#2012-99
296 Liberty Drive (Sea Level Diving)
Project Review for Planning and Zoning Commission

Meeting Date: October 3, 2012

Location: 296 Liberty Drive

GEOMETRY PLAN

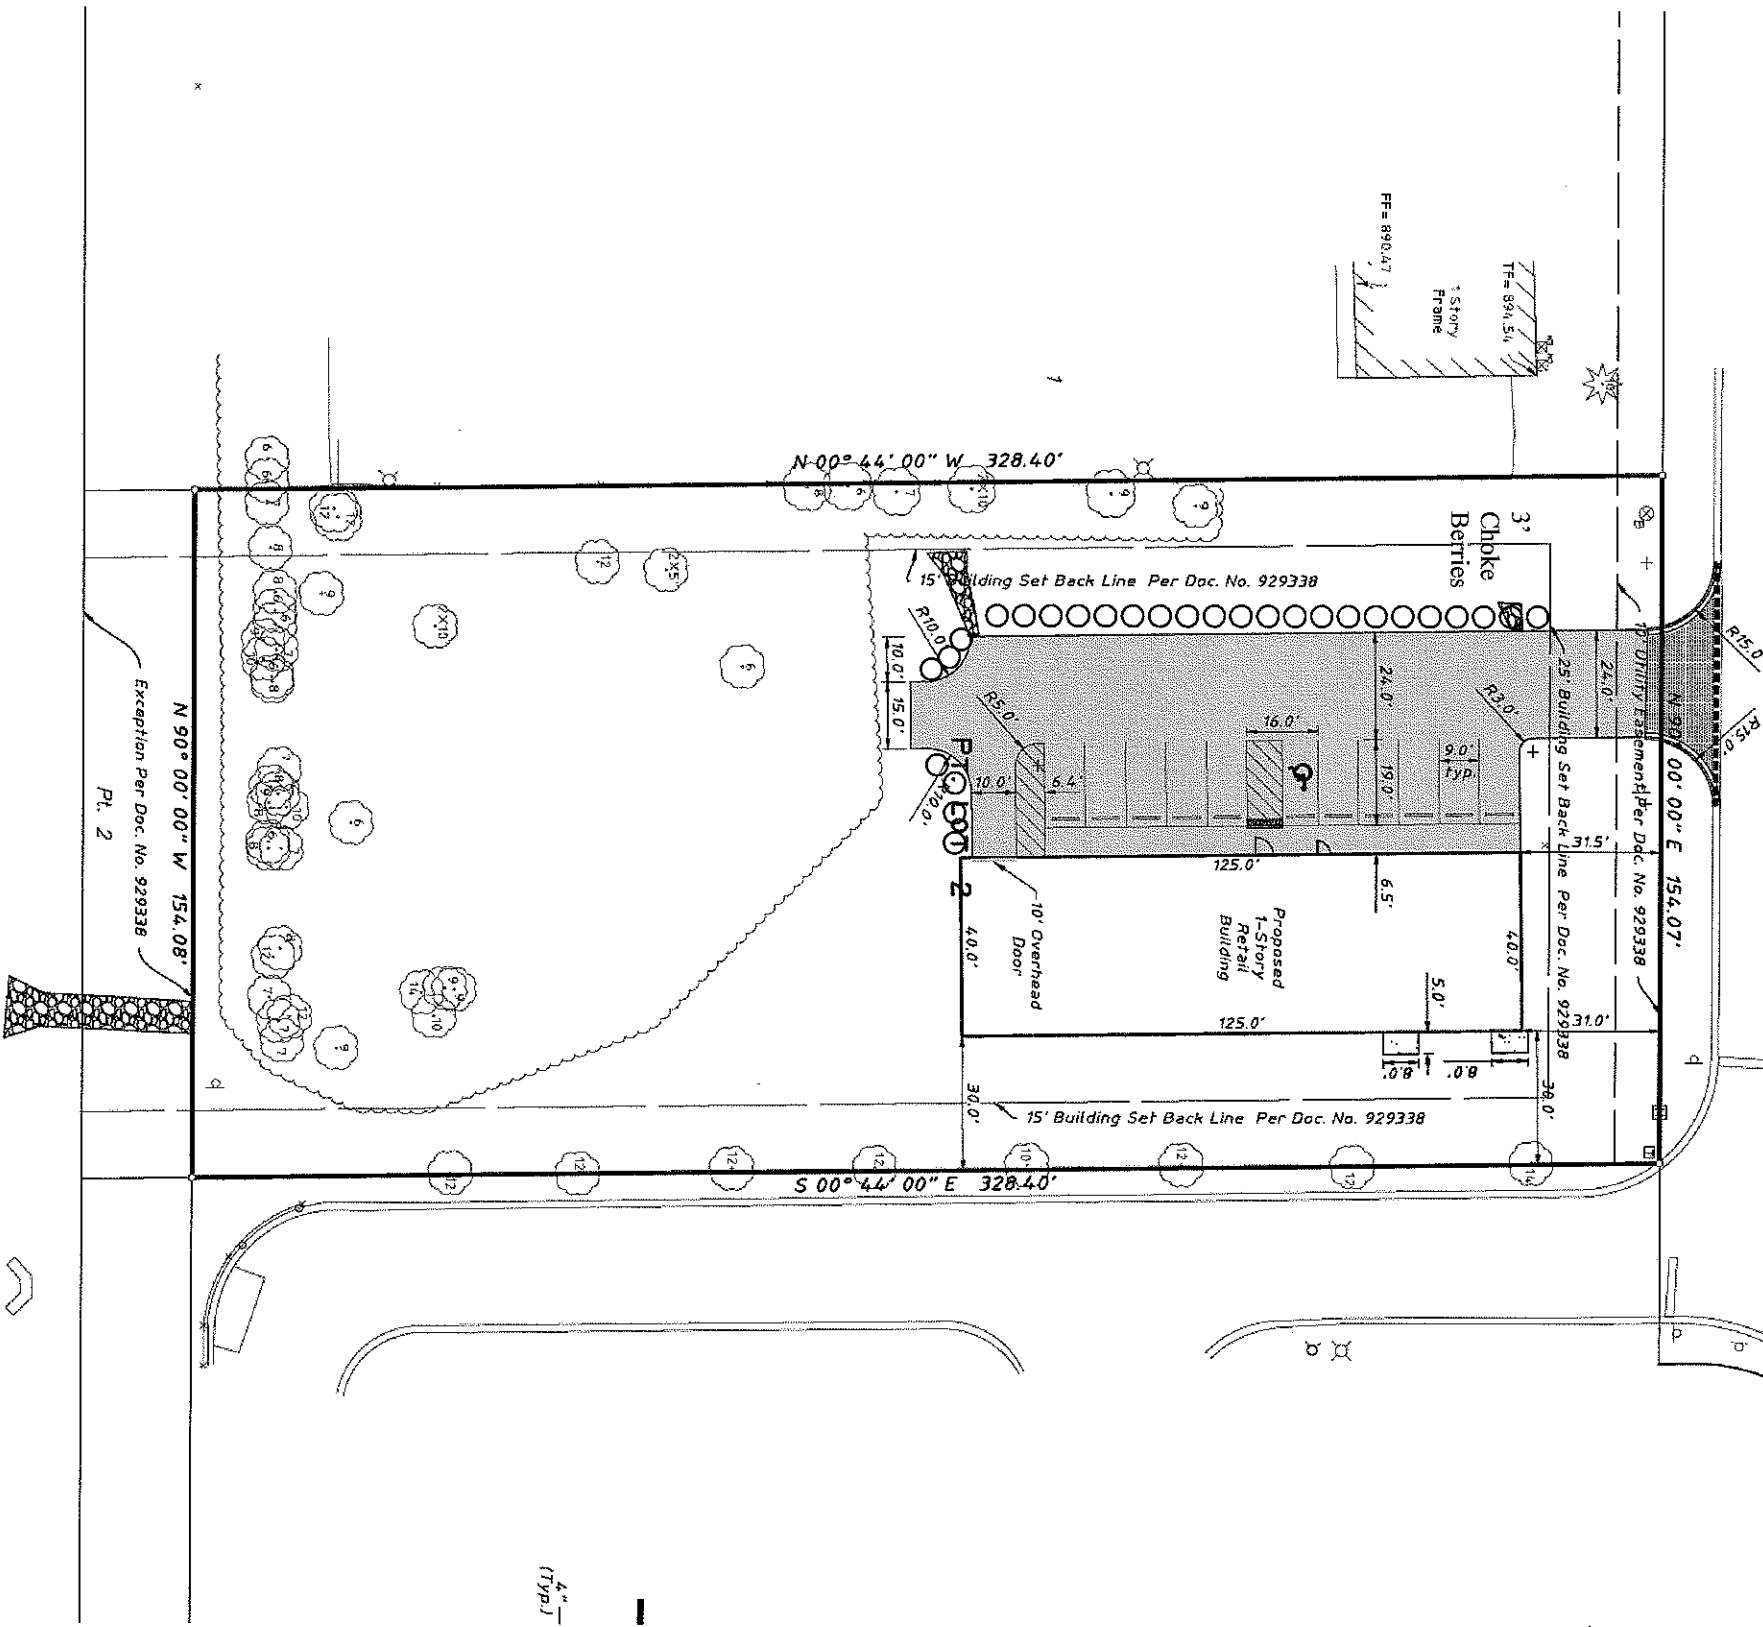
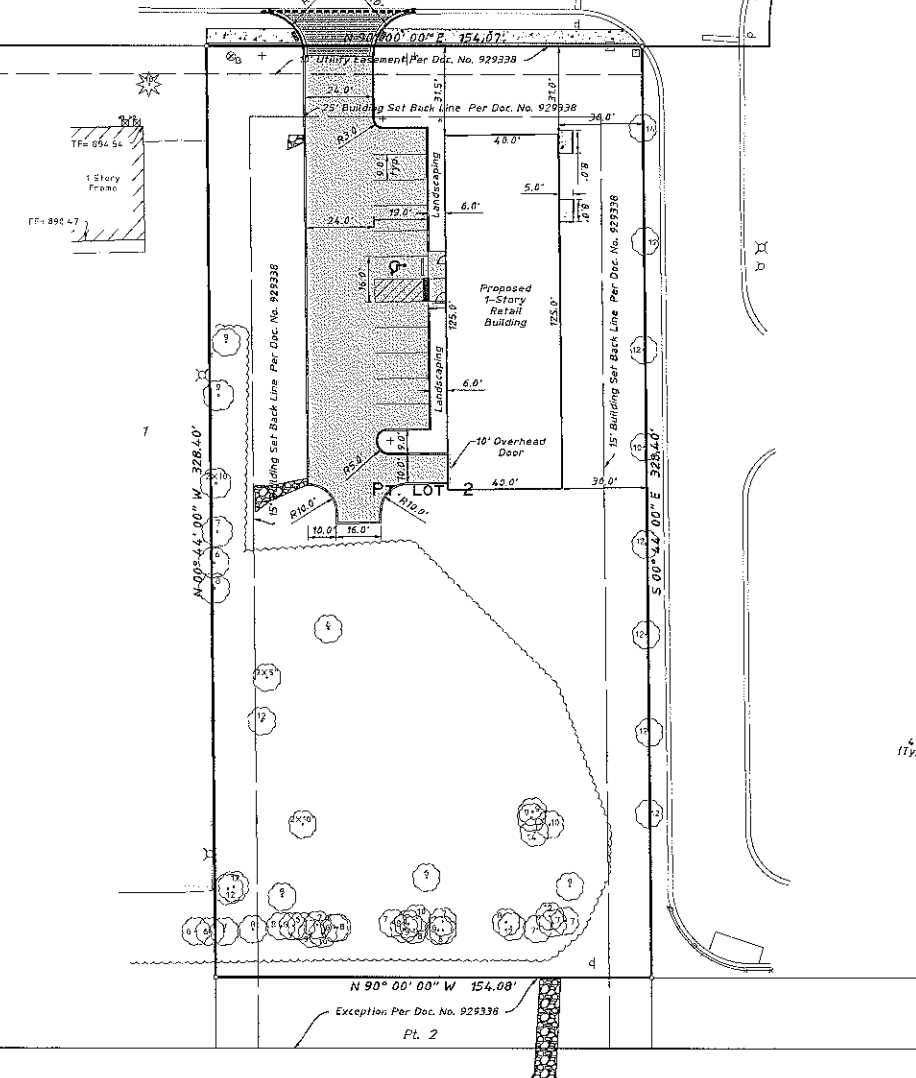
- The building is located perpendicular to Liberty Drive with the driveway and parking lot to the west.
- Water would drain off the west side of the parking lot into a swale down to the detention basin to the south.
- The petitioner would sheet flow the water into the landscape swale; the curb would prohibit this type of water flow, which is why the variation is being requested.
- Currently, sidewalk does not exist along the frontage of this parcel and the two adjacent parcels to the west. The petitioner is requesting a variation from the requirement to install sidewalk, asking for a deferral until the adjacent properties can be part of a larger sidewalk installation. Sidewalk also does not exist along the parking lot to the east.

- The site contains existing trees on the west and south sides of the property.
- The petitioner will add landscape around the west side of the parking lot for the swale and screening.
- Foundation base landscape will be planted around the perimeter of the building.
- Parking lots are required to be screened, additional landscape materials are required in the landscape island along the north side of the parking lot.

3. Add additional landscape materials in the end landscape island on the north side of the parking lot to screen the parked cars.

2. The following variations are granted:
 - A. A variation to install the sidewalk, deferring the installation until an area wide program is established or within 5 years whichever is sooner.
 - B. A variation from the requirement to install curbing around the perimeter of the parking lot and the landscape island.
 - C. A variation from the requirement to have a landscape island at the end of the row as well as every ten spaces.
